Travis County Commissioners Court Agenda Request

Meeting Date: January 15, 2013

In Basic Development Permit Application #12-1748, Lake Travis ISD proposes to develop a 32.46 acre tract at 4932 Bee Creek Road, in the City of Lakeway ETJ, to construct the New Middle School, including associated drives, sports fields, utilities, water quality controls, and detention structures. The proposal is subject to the development permitting requirements of Travis County and City of Lakeway. The tract for the school site generally wraps around the top of a hill with steep slopes facing west and downhill to a tributary of Bee Creek. Approximately 27% of the site has slopes greater than 15%. The site consists of mixed grasses and dense wooded areas adjacent to a horse farm. The applicant requests two variances to allow the preferred development configuration in spite of the topographic challenges of the site. The applicant also requests a variance from fiscal security requirements.

VARIANCE REQUESTS FROM LAKE TRAVIS INDEPENDENT SCHOOL DISTRICT PERMIT APPLICATION #12-1748

WATERWAY SETBACK DIAGRAM

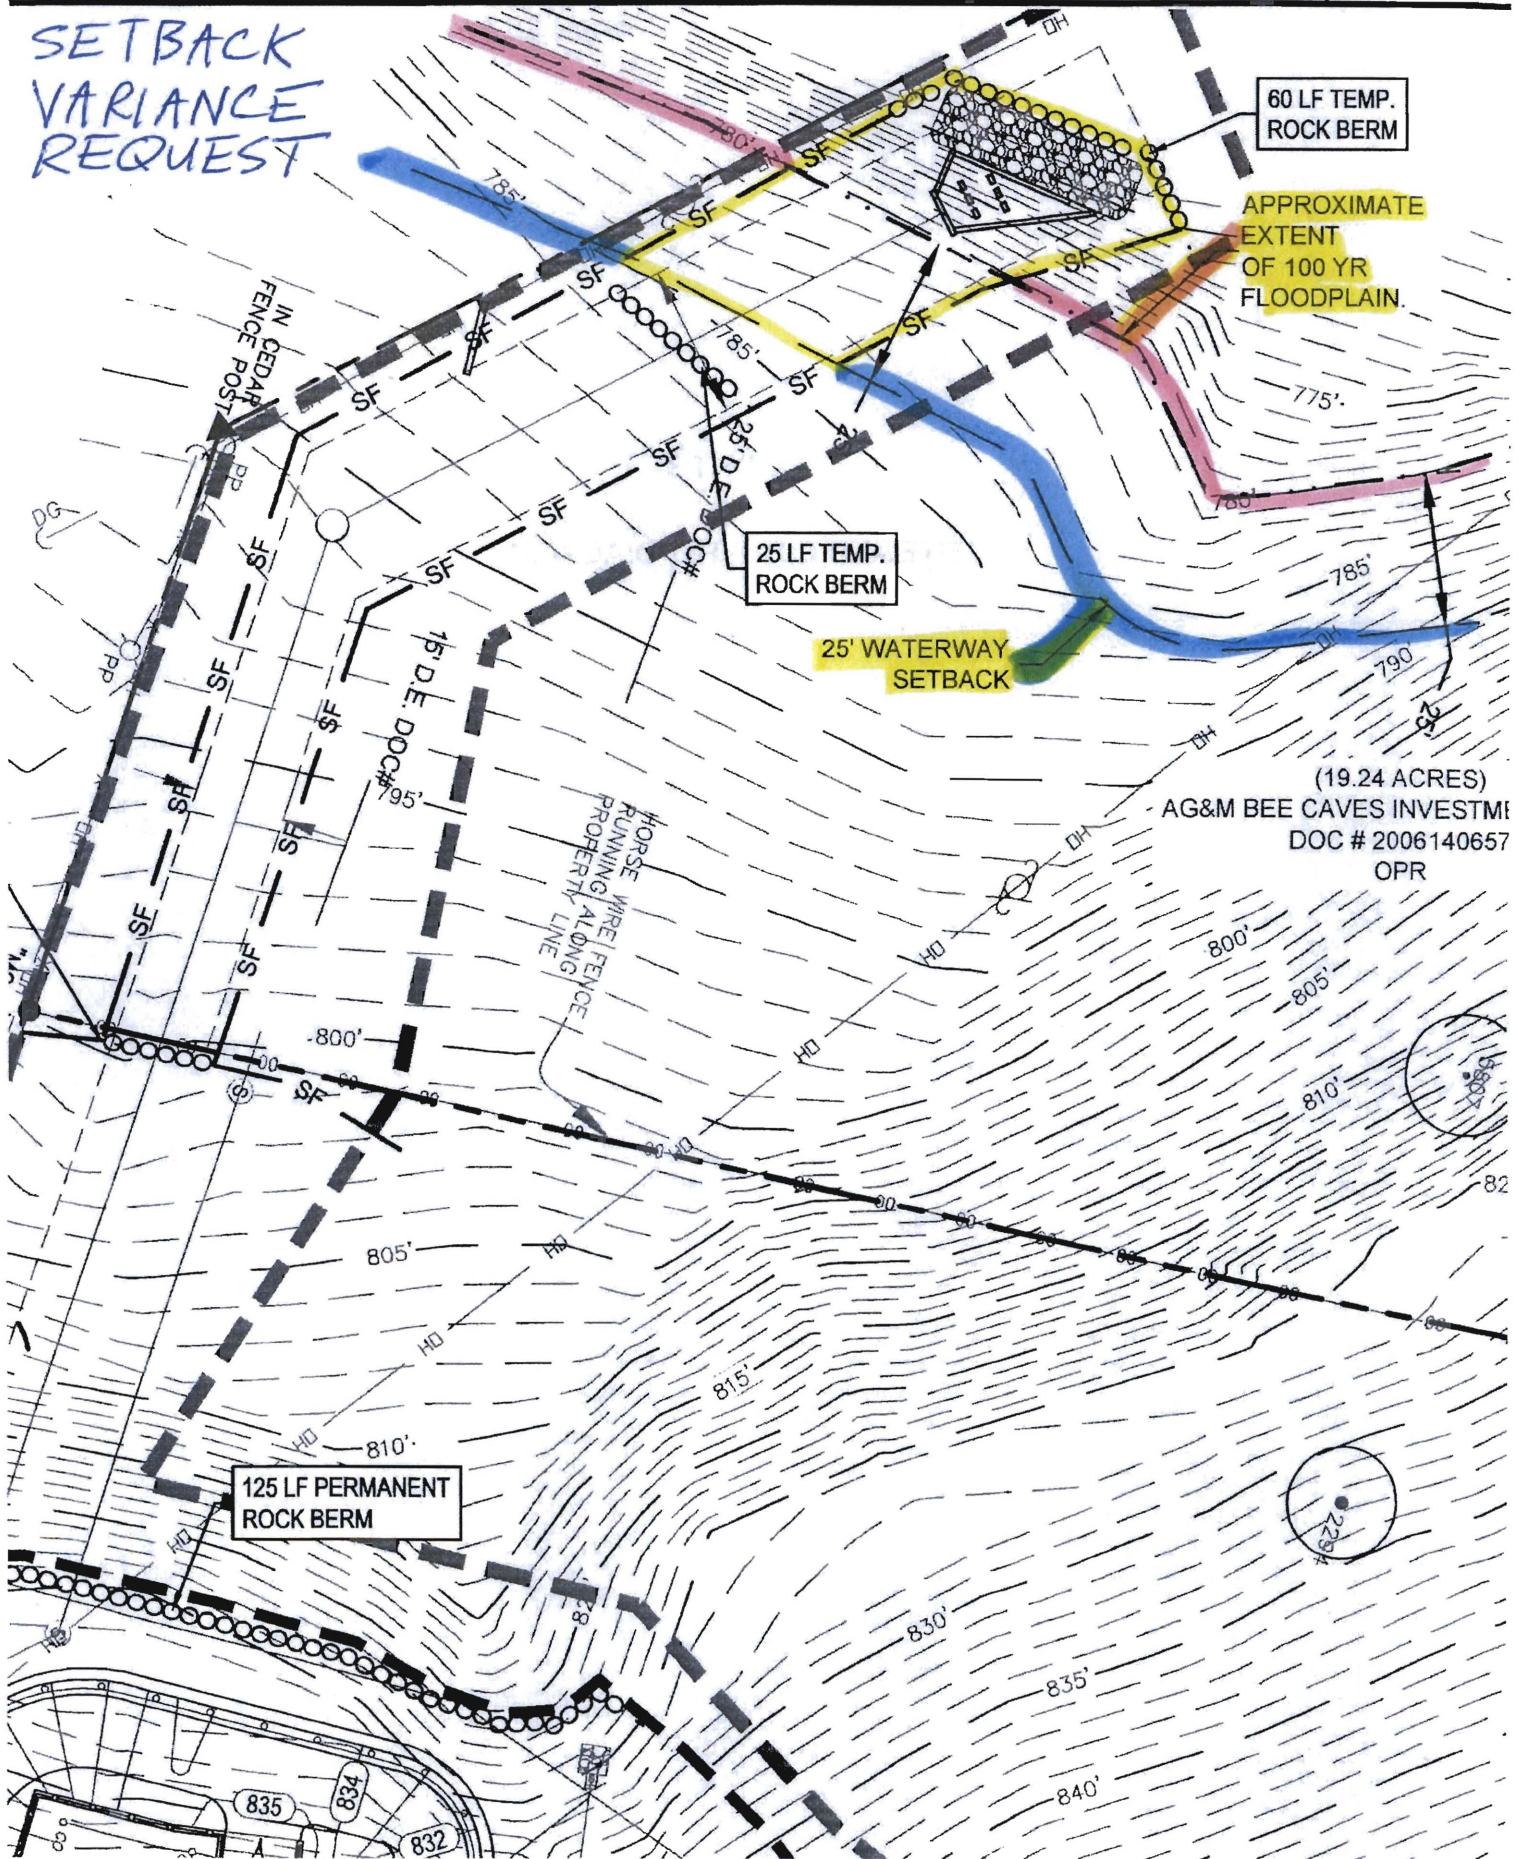
Variance A would allow construction of a storm sewer outlet headwall within the waterway setback of a tributary of Bee Creek. Section 82.941(h)(1)(B)((i) of the Travis County Code requires a setback of 25 feet from the 100-year floodplain boundary of a waterway. Section 82.941(i) requires that setbacks shall remain free of construction, development, and other alterations. Section 82.941(i) also requires that drainage patterns from development be dispersed into sheet flow before reaching the setback area.

The attached storm sewer plan shows the proposed alignment of the storm sewer line and the proposed headwall construction within the Waterway Setback (indicated thereon as a 25' setback from the approximate 100-yr floodplain). Our design entails the construction of a 36" concrete headwall/stilling basin at the base of the existing stream bank with a large rock splash pad in the stream bottom. We've estimated the cost to construct this headwall/stilling basin at approximately \$12,000, the large rock splash pad at \$1500, and additional 36" storm sewer line constructed within the waterway setback at approximately \$12,500 for a total estimated cost for the work within the setback at \$26,000.

1. Discharging this large amount of storm water outside of the Waterway Setback would require the construction of a large flow spreader set back a minimum of 25' from the top of the stream bank. In this area, the stream bank is a mix of old alluvial deposits and severely weathered limestone and caliche, which is prone to erosion. Assuming that it was feasible to distribute the storm sewer discharge as sheet flow (less than 2" depth to minimize erosion in this erosion prone material), the weir flow equation gives a required weir length of 563' long for the 115 cfs in the design storm. In addition to a concrete flume/weir, a loose rock splash pad would also be necessary along the length of the spreader. At an estimated \$75/lf for a concrete flume/flow spreader, this would be approximately \$42,225 in addition to the cost of the proposed headwall/stilling basin (\$12,000) for a total estimated cost of \$54,225. Since the location of this flow spreader would be on an adjacent property owner (not LTISD property), it is likely that there would be additional unknown costs/hardships involved to procure the necessary easement/property to contain the required flow spreader. It is also probable that despite attempts to spread the flows out, the continual discharge of flows directly at the top of this bank will lead to severe erosion of this stream bank.

2. By discharging directly to the stream bed in lieu of constructing a long flow spreader as required to distribute this large amount of flow outside the Waterway Setback, the proposed plan will minimize the long term maintenance otherwise needed to ensure the design functionality.

3. The proposed construction of the storm sewer outlet headwall within the Waterway setback includes the placement of large rock dissipaters (12"-15" in size) at the lip of the headwall. Field reconnaissance indicates the existing stream bed in this area is bedrock, which would negate the need for rock dissipaters. We are proposing the use of flowable backfill behind the proposed headwall and over the proposed section of the storm sewer built within the waterway setback. Silt fence will be used around the perimeter of construction, a temporary rock berm placed at the headwall within the setback, and temporary rock berms will be placed at intervals along the length of the storm sewer construction from the headwall up to the pond splitter box. Construction will proceed from the lower end at the creek bank up to the pond splitter box. As individual sections of line are backfilled, the surface shall be restored with seeding and soil blankets as soon as practicable and the temporary rock berms relocated up the hill to act as a temporary BMP for the next section of line under construction.

Staff recommend approval of Variance A. Lake Travis ISD proposes placement of a storm sewer outlet headwall within the waterway setback in a drainage easement granted by the adjacent property owner (See Exhibit 2). Staff agrees with the applicant that the encroachment into the setback would allow for more certain compliance with Section 82.941(i) at significantly less cost while significantly dissipating the velocity and energy of the flow at the outlet point. While the variance is caused by the method chosen by the applicant, the staff believe the location of the storm sewer outlet below the steep slope will achieve greater environmental protection and reduces the probability of soil erosion and harmful environmental consequences than if the storm sewer discharged above the steep slope and outside of the waterway setback. Staff also have determined that the applicant's variance request is a method that makes minimal alteration of the waterway setback area (affected area equals 1821 sq. ft. or 0.041 acre), includes sufficient erosion and stabilization controls while construction of the storm sewer occurs.

SITE AND CUT & FILL DIAGRAM

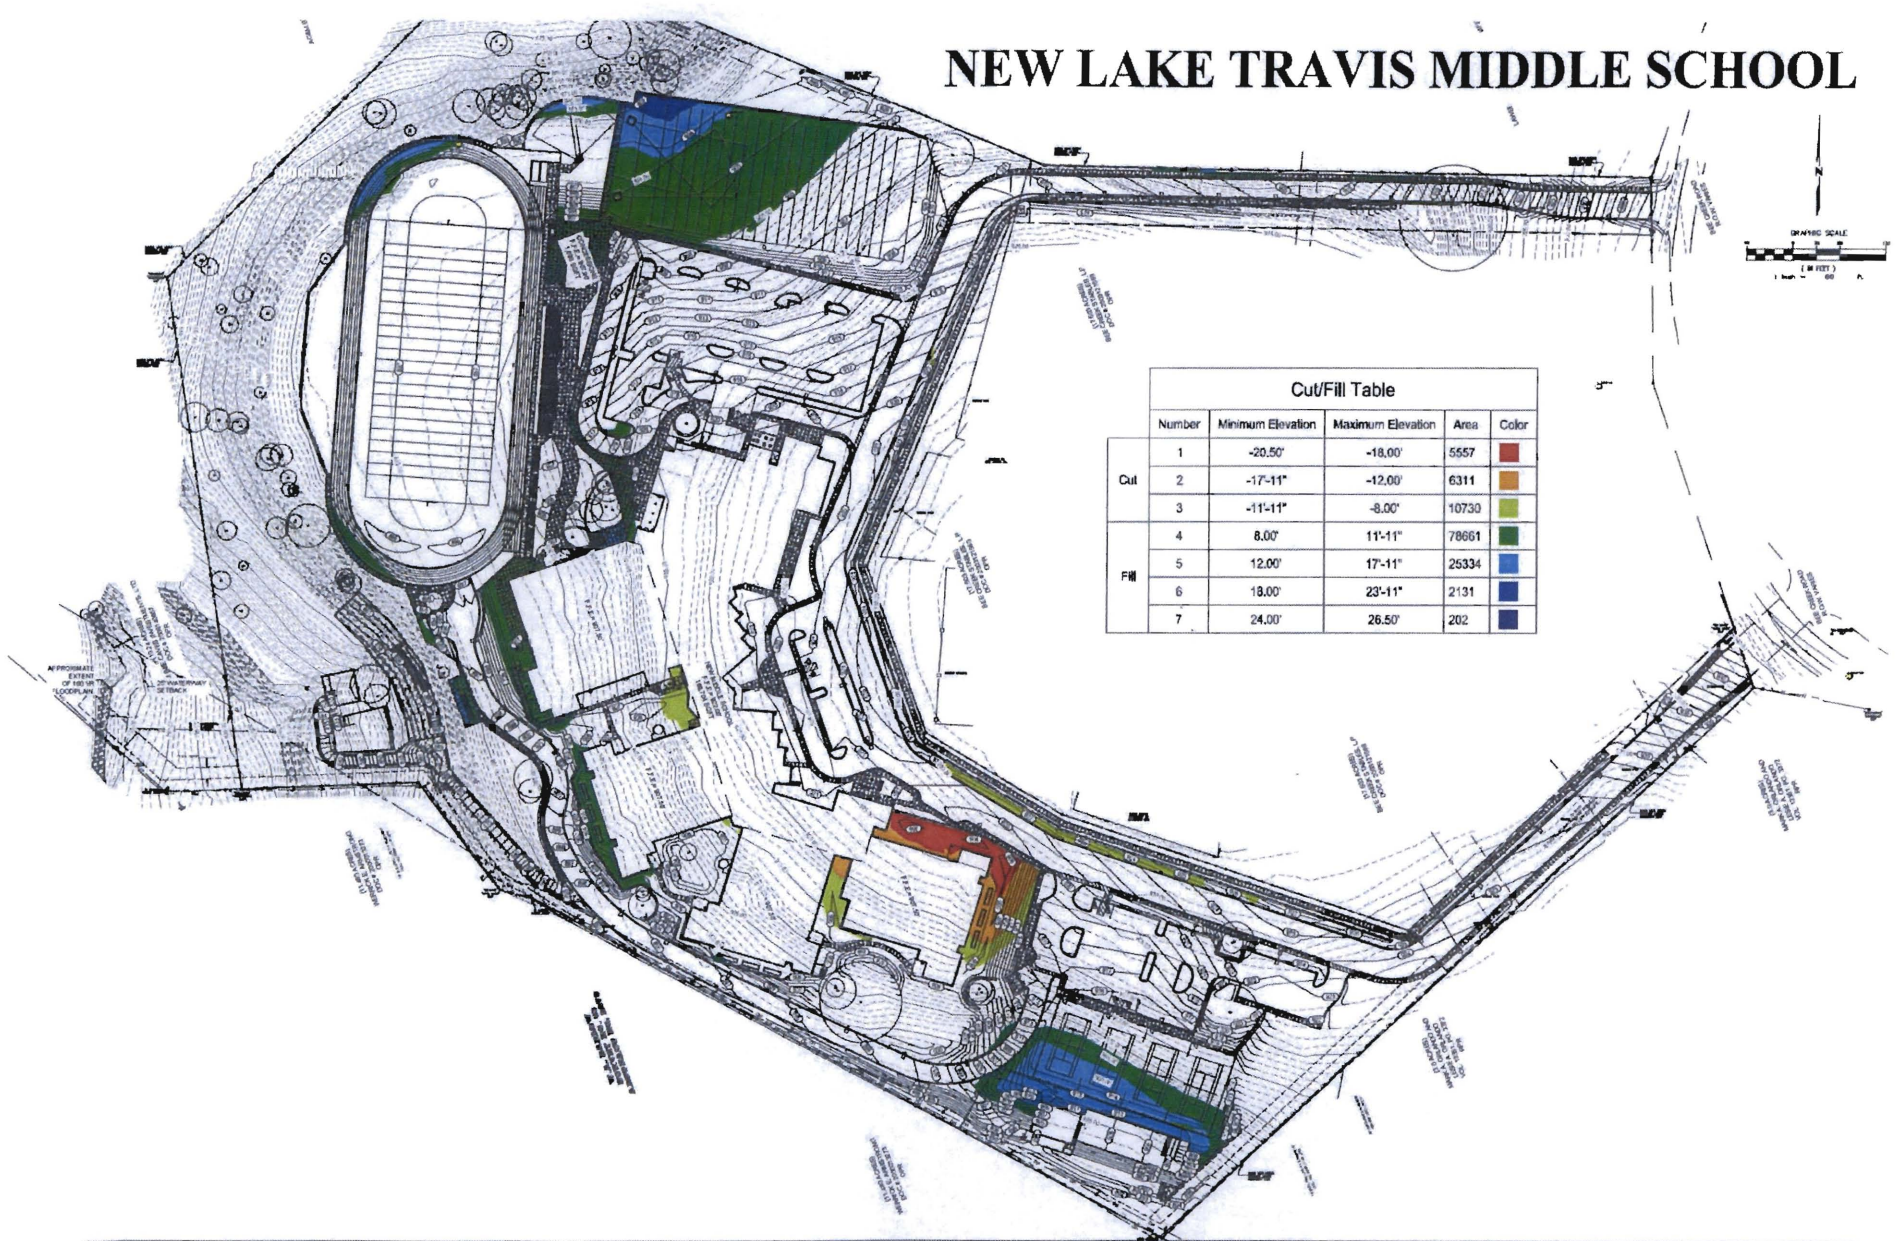
Variance B would allow land grading changes including excavations ("cuts") and placement of fill material to exceed eight feet of elevation change, in order to construct the school and associated structures on this site. Section 82.943(a)(1) of the Travis County Code specifies that all cut and fill land balancing is limited to a maximum of eight vertical feet.

The attached exhibit shows the proposed site and grading plan and delineates in different colors cut/fill areas ranging from 8' to 11'-11", 12' to 17'-11", 18' to 23'-11", and 24' and greater.

2. It is not feasible to fully comply with the requirements of Sec. 82.943(a) while accommodating all of the educational programs and athletic functions required for a middle school. At a minimum, full compliance would require the elimination of the practice and competition fields (areas 'A', 'B', 'C' and 'D') due to the size of their respective footprints, and the natural topography in these areas.

3. As requested by Sec. 82.921(b)(2), the following is an approximate design and cost comparison of the proposed designs for each area exceeding the 8' cut/fill limitation to a hypothetical design not exceeding the 8' cut/fill limitation. Please note that these are hypothetical scenarios used for discussion only as we don't believe that they would all be feasible when integrated over the entire site.

4. The total area involved in this variance request is approximately 0.519 acres of cut and 2.441 acres of fill. These areas are broken down on the attached exhibit accompanying this variance request.

Staff recommend approval of Variance B. Lake Travis ISD proposes placement of land balancing cuts totaling 0.519 acres and fill placement totaling 2.441 acres. Exhibit 3 shows the specific locations proposed for the cut/fill. Staff agrees with the applicant that cuts and fills exceeding eight feet are important in order for design a functional site that provides educational services on this topographically challenging location. Without the variance, all athletic functions would not be possible and the practice and competition fields would need to be limited due to the topography. The applicant notes that the amount of cut/fill is minimized due to the school design of a split level building, use of terraced retaining walls, and placement of 73% of the facility on slopes of less than 15%, more closely following the natural terrain.

The potential environmental impact of the cut/fill is mitigated by the applicant. First, TNR is requiring a detailed sequence of construction to limit the runoff impacts from disturbed land. Secondly, use of reinforced concrete, engineered retaining walls on the site will contain fill and armor the faces of the cut slopes in the cut areas and the embankment materials in the fill areas. Also, certain steep slopes will be sodded with solid grass or will use permanent rock berms. These measures will provide for an equivalent level of environmental protection when compared to shallower cut/fill and the proposal does not create a significant probability of environmental harm.
